STAFF RECOMMENDATION
2700 Oakland Avenue
June 19, 2019

Application: New Construction—Addition and Outbuilding
District: Belmont-Hillsboro Neighborhood Conservation Zoning Overlay
Council District: 18
Base Zoning: R8
Map and Parcel Number: 11704016700
Applicant: Manuel Zeitlin
Project Lead: Paul Hoffman, paul.hoffman@nashville.gov

Description of Project: This application is for a rear addition to this contributing building.

1 Site Plan
1" = 20'-0"

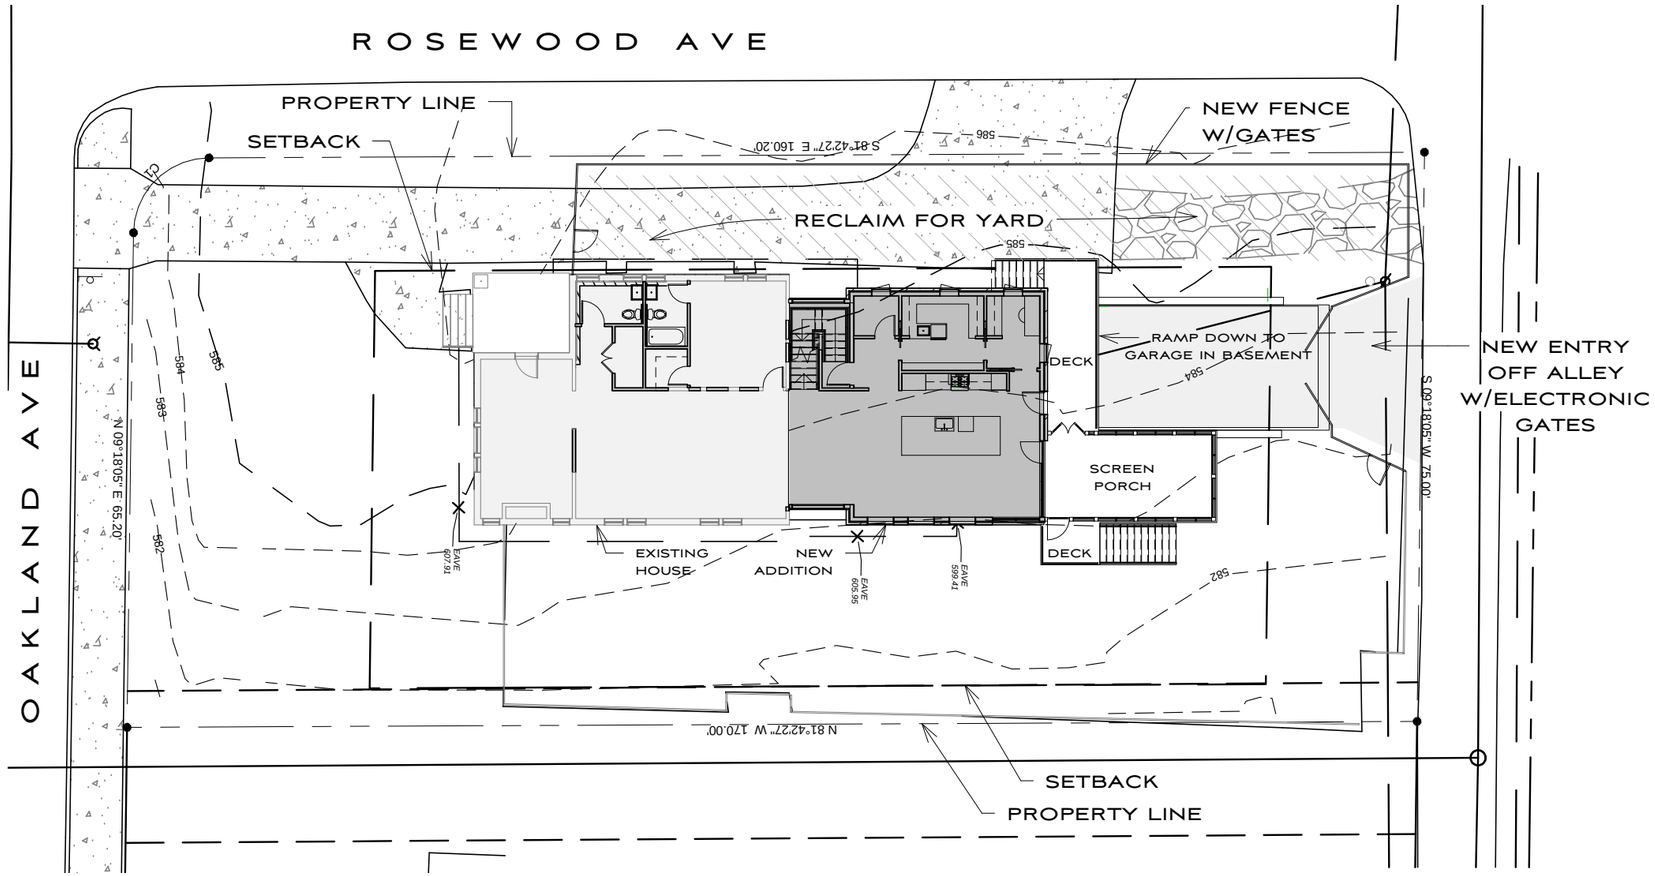
Appurtenances & Utilities: A new driveway will be constructed at the rear. A new fence and gates are proposed. The portion of the driveway that goes alongside the house to the rear yard is drawn being removed leaving the current driveway as "front-yard" parking, which is not appropriate. Staff recommends the existing driveway configuration to be retained. The project meets Section II.B.1.h.

1. The horizontal window on the street side of the addition is revised to a traditional window proportion;
2. The foundation line is differentiated with a soldier course;
3. The driveway configuration to the rear yard is retained;
4. Staff approve the final details, dimensions and materials of windows, doors and garage door prior to purchase and installation; and,
5. Staff approve the walkways, driveways, roof color and masonry color, dimensions and texture.

1 Level 1 - Demolition Plan
1/8" = 1'-0"

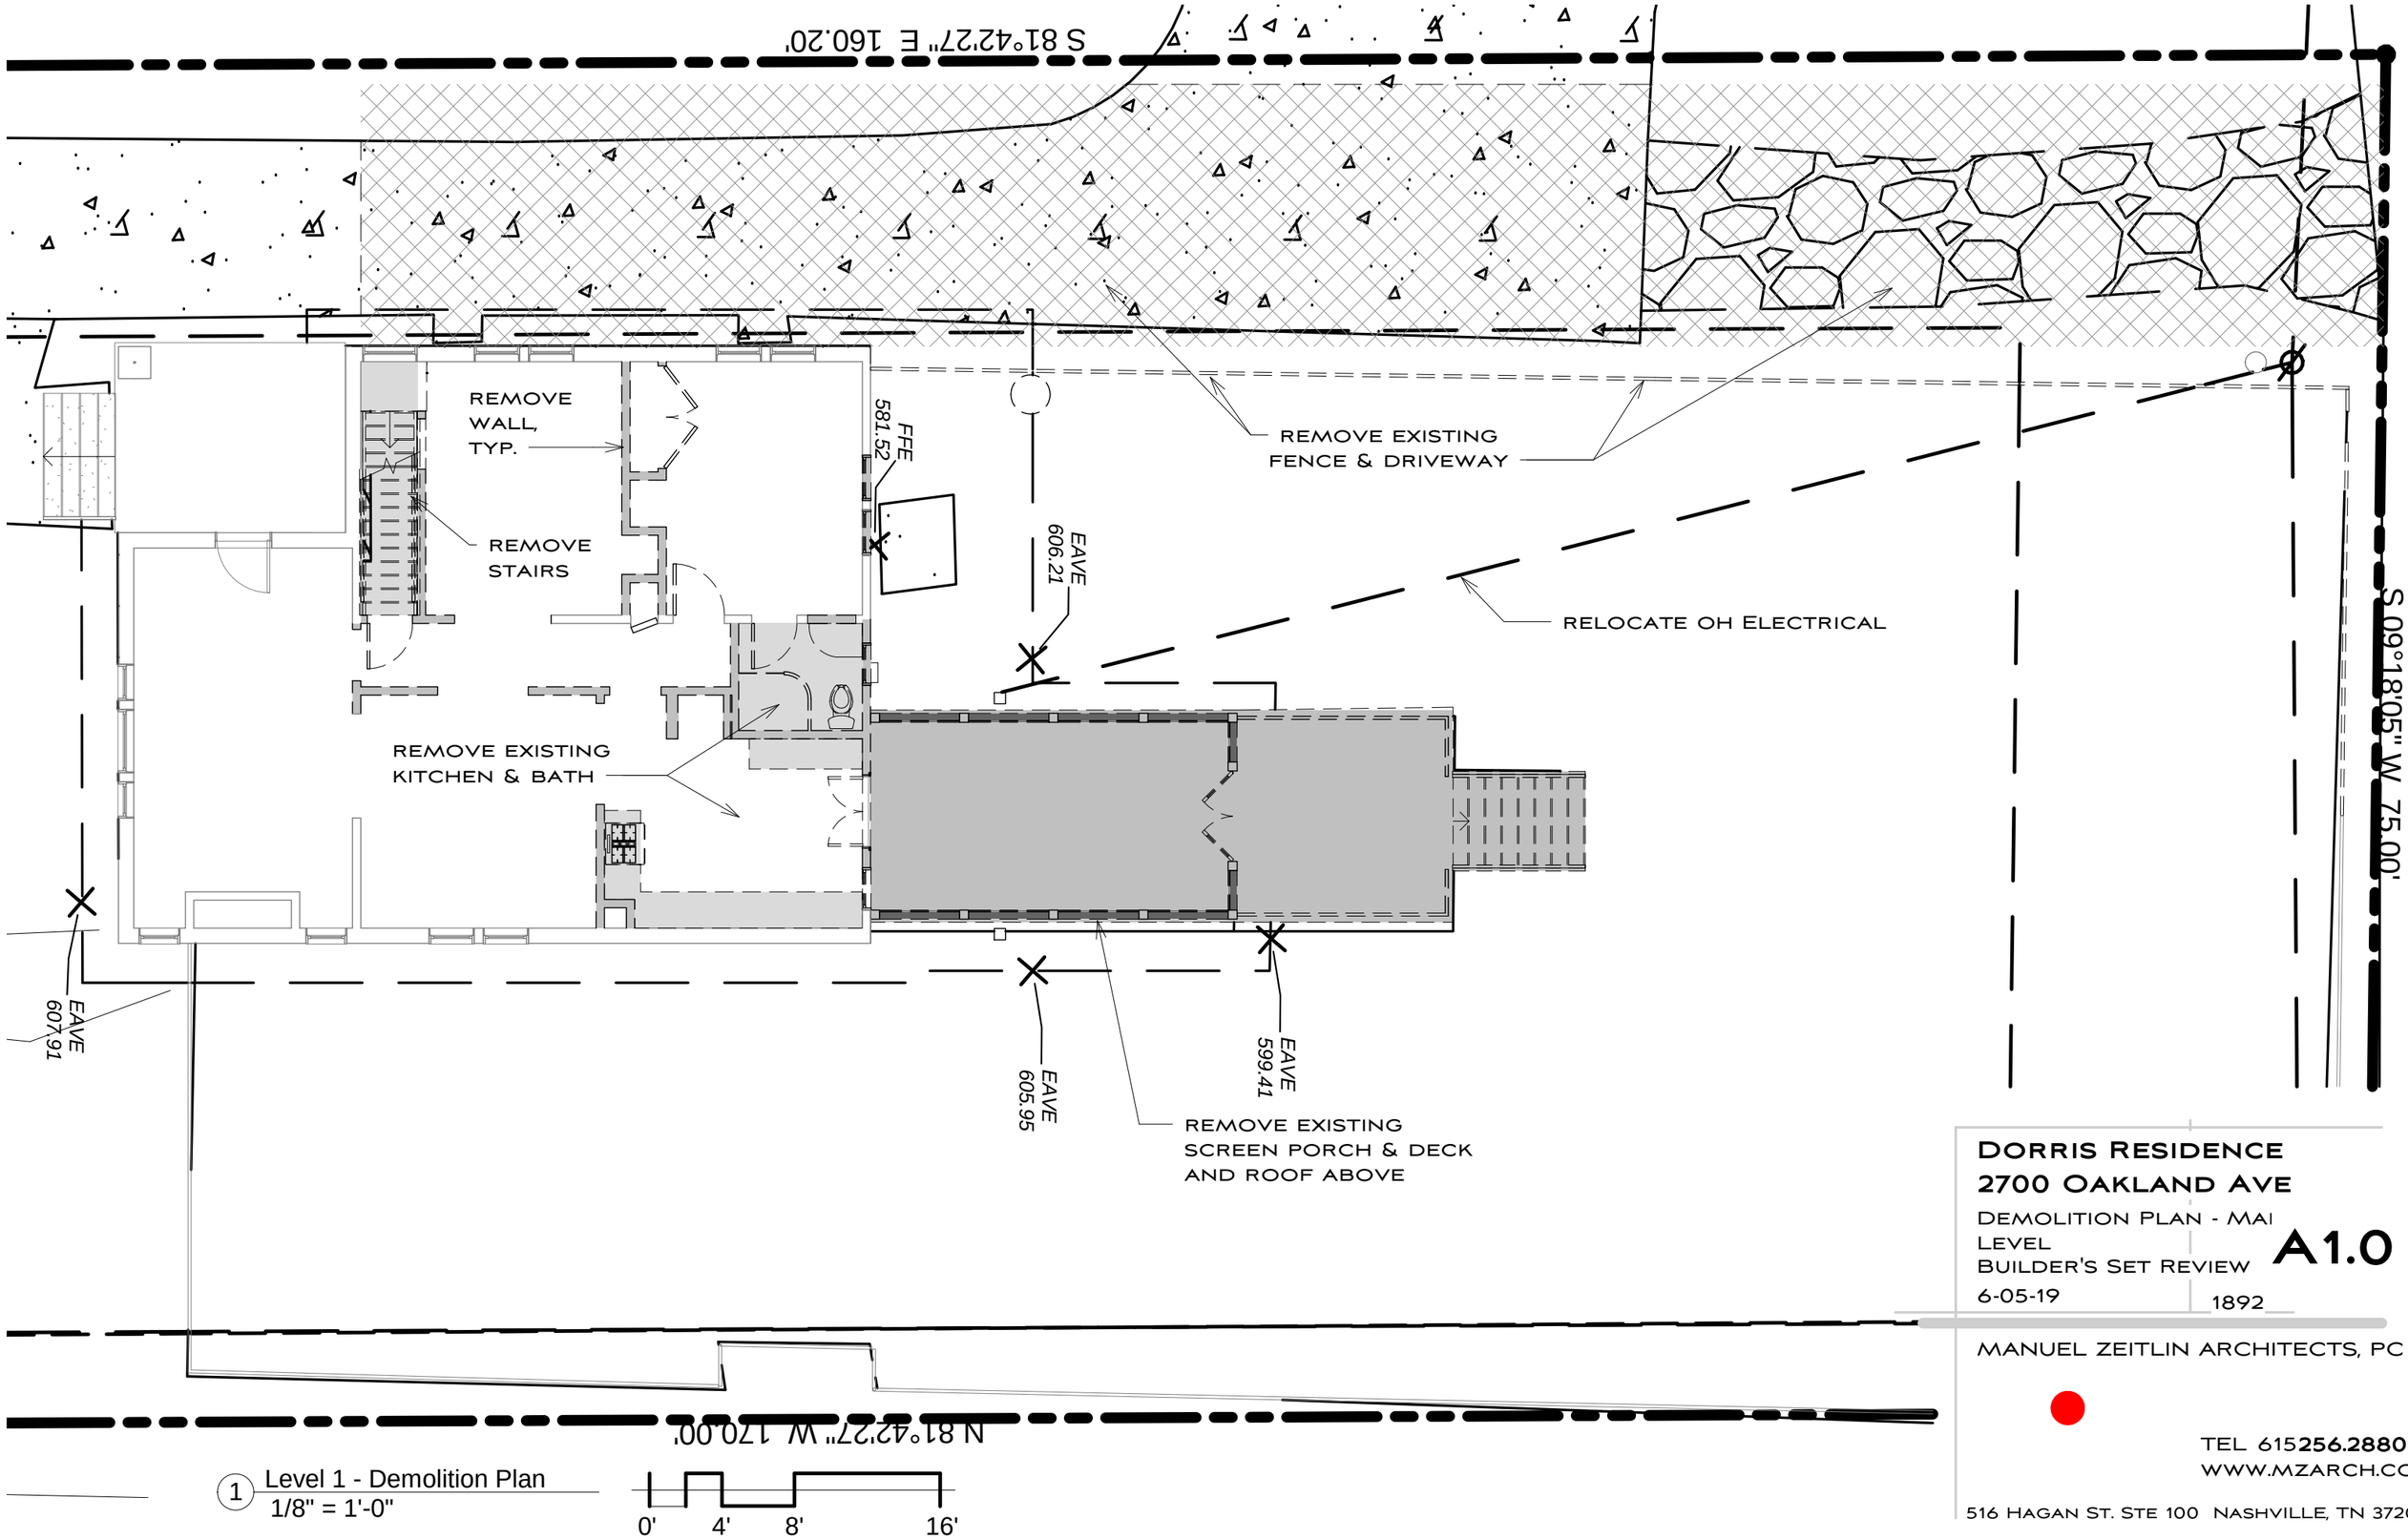
Partial Demolition: The application proposes removal of an existing shed-roofed screened porch (Figure 2) and approximately fourteen feet (14') of the rear of the house. The porch is not architecturally significant, and staff finds that its removal meets the guidelines for demolition. Likewise, the removal of the portion of the rear wall of the house will not affect the historic or architectural integrity of the historic house. Staff finds that the proposed partial demolition meets Section V.2 of the design guidelines for appropriate demolition and does not meet Section V.1 for inappropriate demolition.

1 Foundation
1/8" = 1'-0"

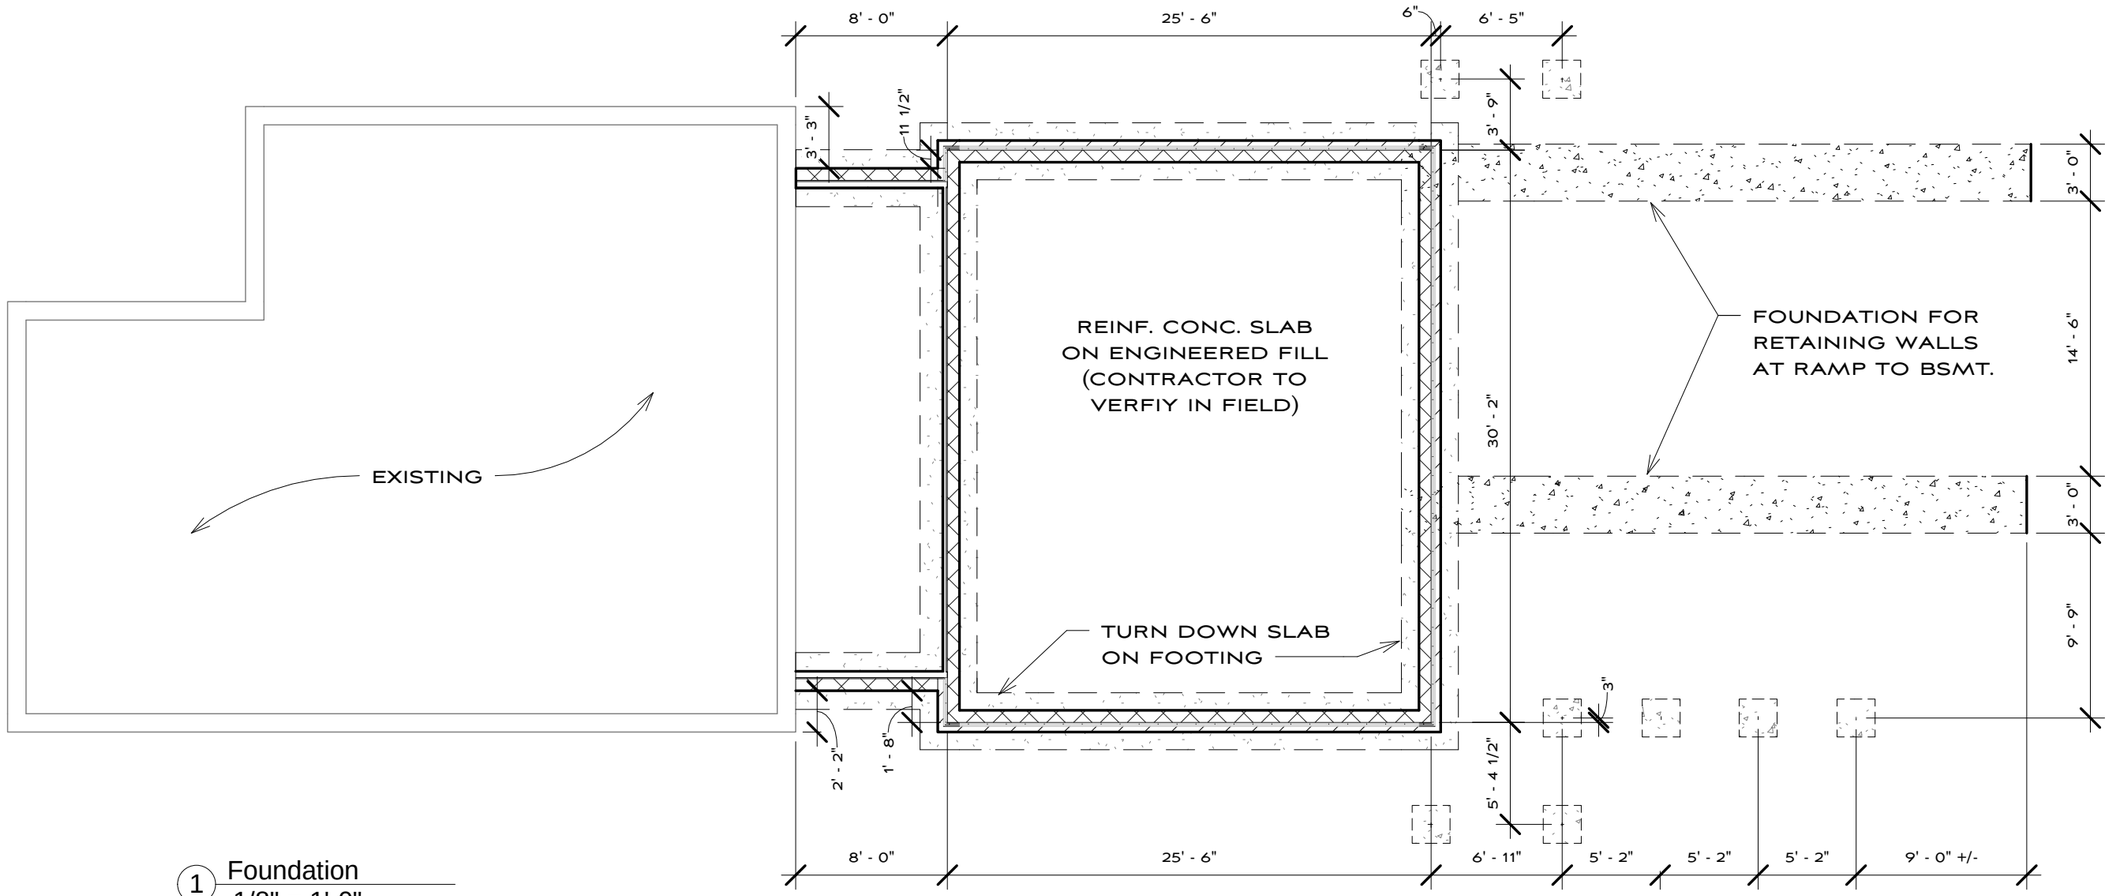
- The addition is proposed to have a brick foundation. Foundation lines should generally be differentiated with a change in material. However the Commission

has approved brick to grade when the foundation line is differentiated with a change in the brick pattern. Staff therefore finds the foundation material appropriate in this case, with the condition that a soldier course or similar differentiation in the brick pattern is added. With the condition that a soldier course is added, and staff approval of the masonry, windows, doors, walkways and driveways and roofing color, the project meets Section II.B.1.d.

1 Roof Plan - Proposed
1/8" = 1'-0"

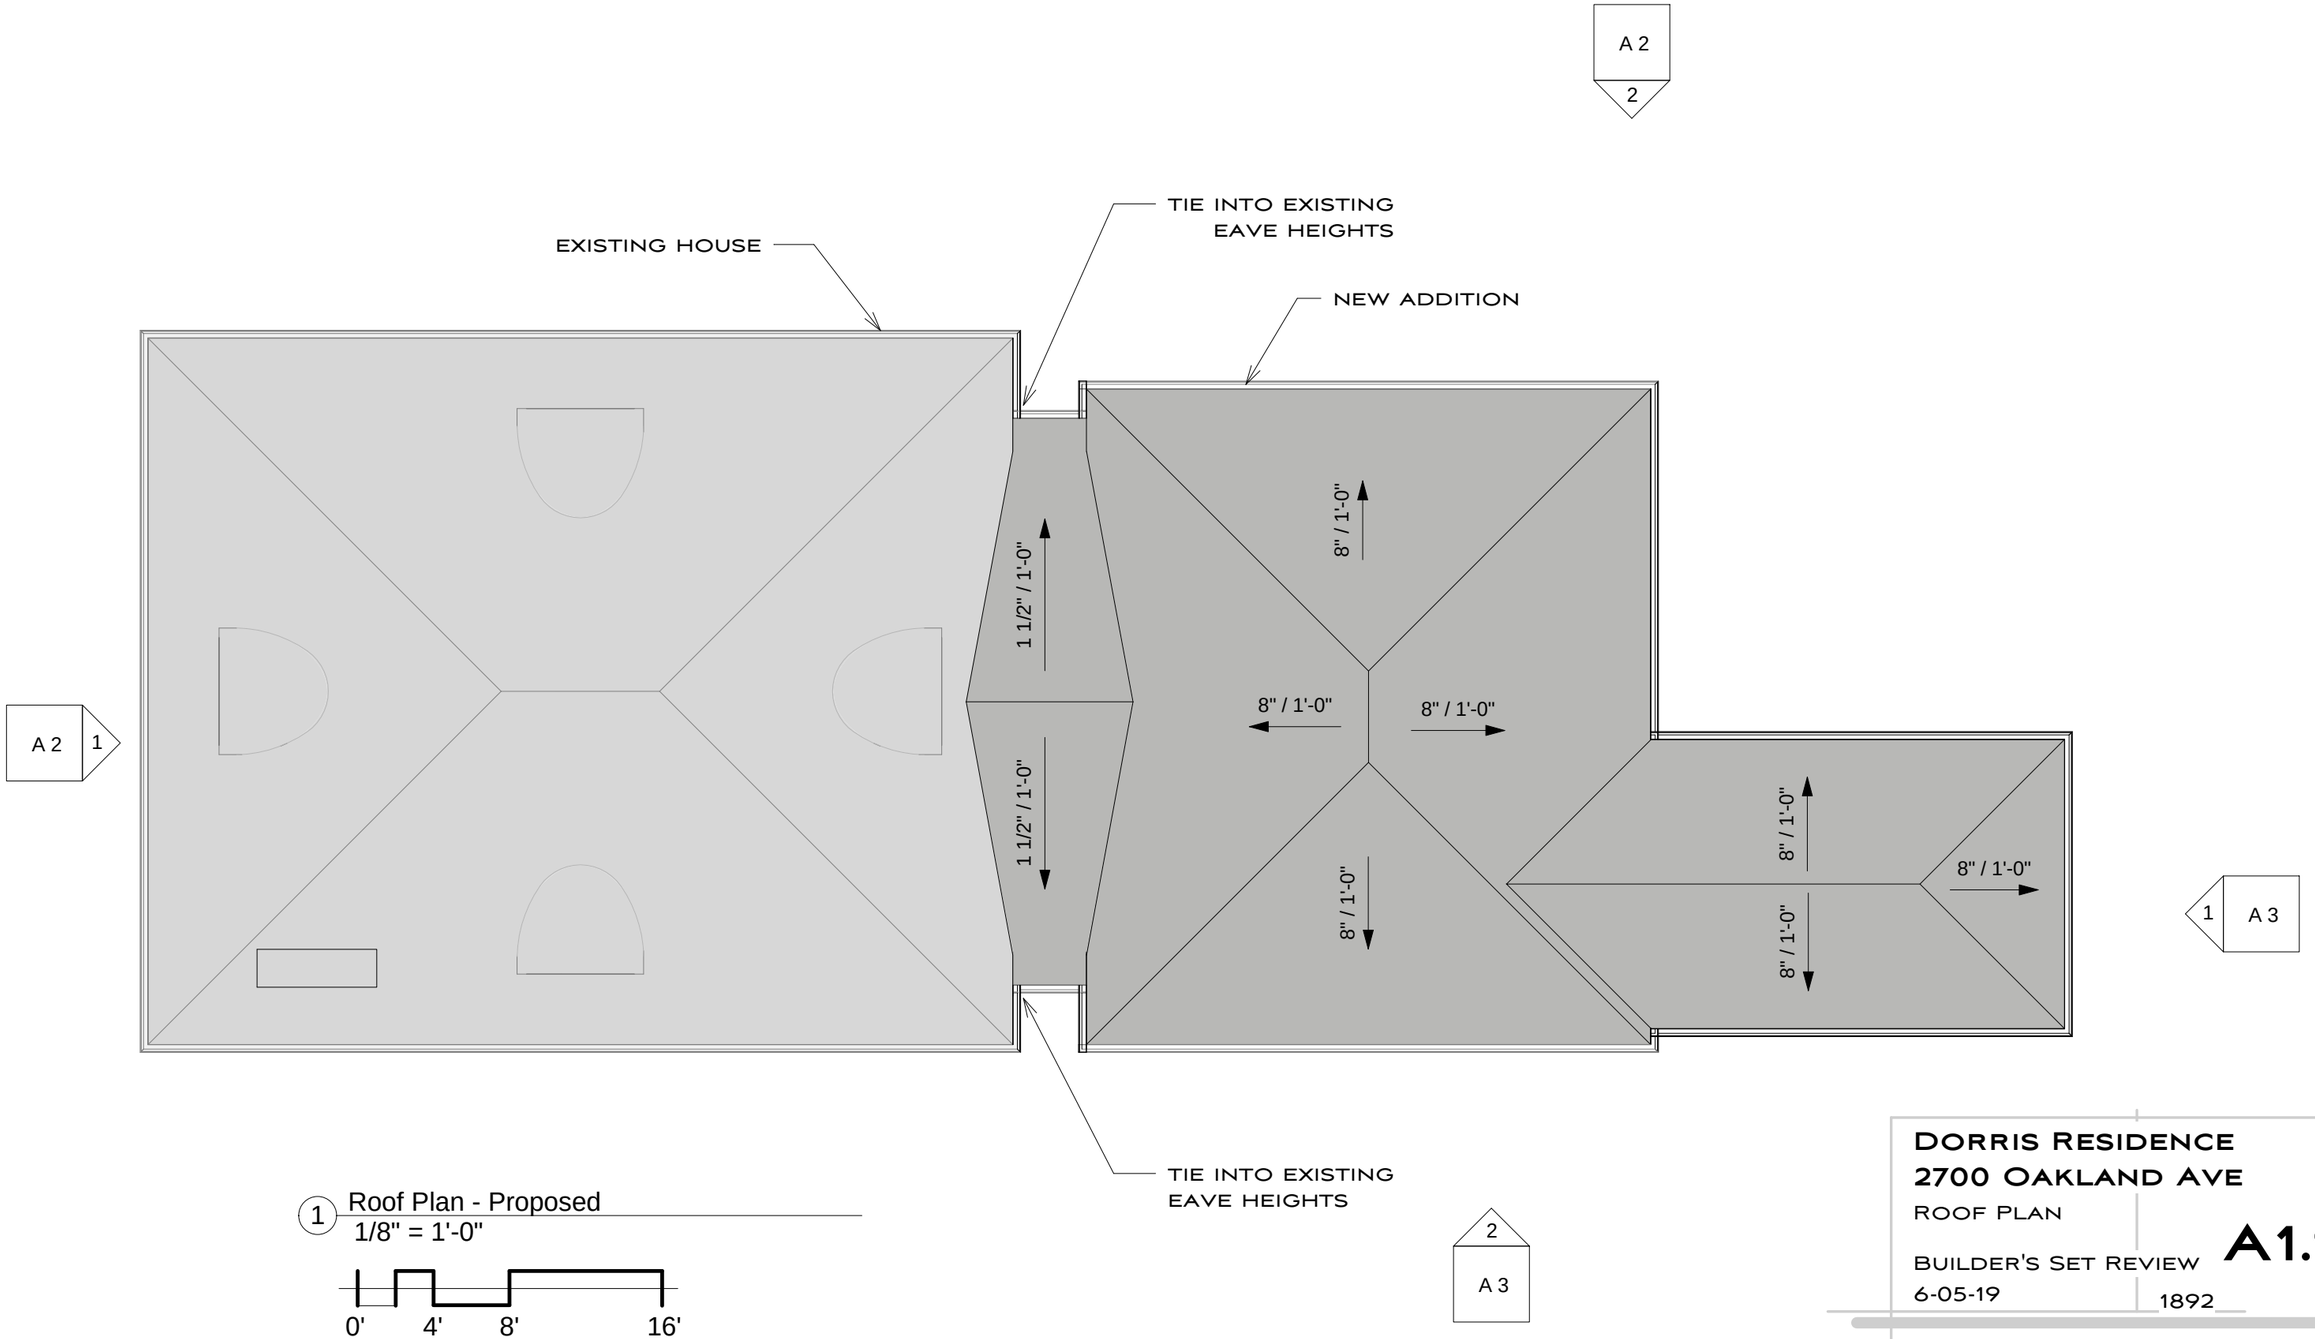
Roof form: The existing house has a hipped roof with 8/12 pitch. The addition connects to the house with a low-sloped connection, and the addition has a pyramidal roof form with 8/12 pitch. The screened porch has a hipped roof with the same pitch. These are typical roof forms seen on other historic buildings in the district. Staff finds that the proposed roof forms are compatible with the historic house and meet Section II.B.1.e.
